MIL-DTL-24231/1E(SH)
w/AMENDMENT 1
13 May 2024
SUPERSEDING
MIL-DTL-24231/1E(SH)
26 April 2013

DETAIL SPECIFICATION SHEET

CONNECTOR, PLUG, TYPE I, MOLDED, THREE-, FOUR-, AND FIVE-CONDUCTOR

FIGURE 3. Plug sleeve – M24231/1-010. (4)

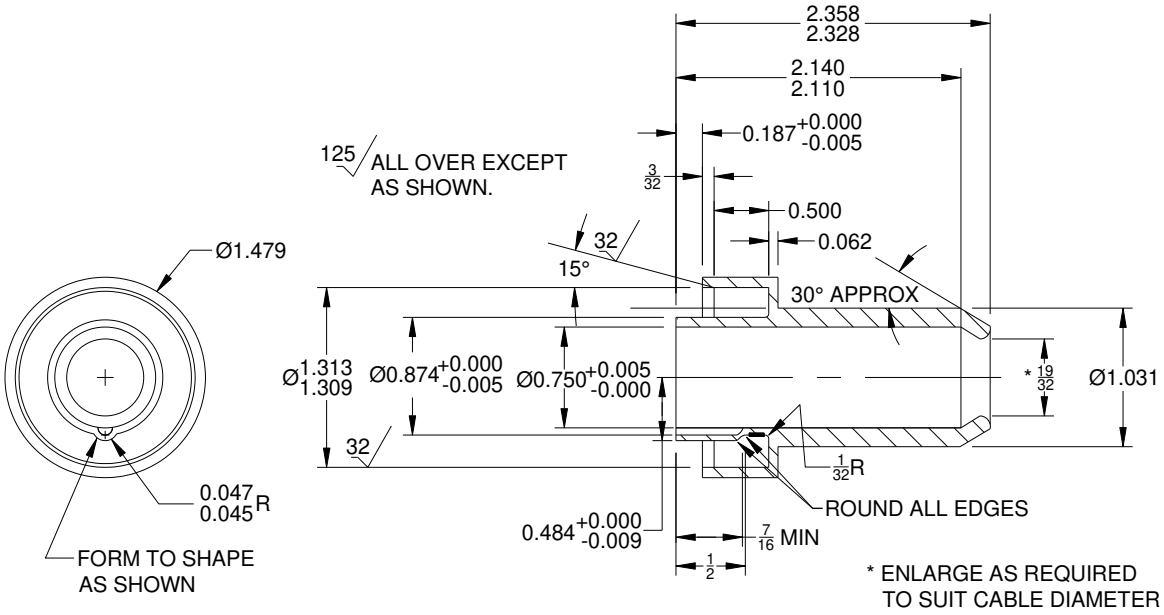
1. Dimensions and configuration: see figures 1 through 6.
2. See table of cable types for molded plugs in MIL-DTL-24231.
3. Ni-Cu plug sleeves shall be coated with plasma spray non-conductive material in accordance with S9320-AM-PRO-030/MLDG.
4. All dimensions are in inches.
5. Tolerances shall be as follows, or as stated:

BACKWARDS COMPATIBILITY. Connectors with glass reinforced epoxy (GRE) plug sleeves procured to MIL-DTL-24231/1E, dated 26 April 2013, are not acceptable for shipboard use and should be disposed of. All future requisitions should be to the current revision of this specification sheet and MIL-DTL-24231.
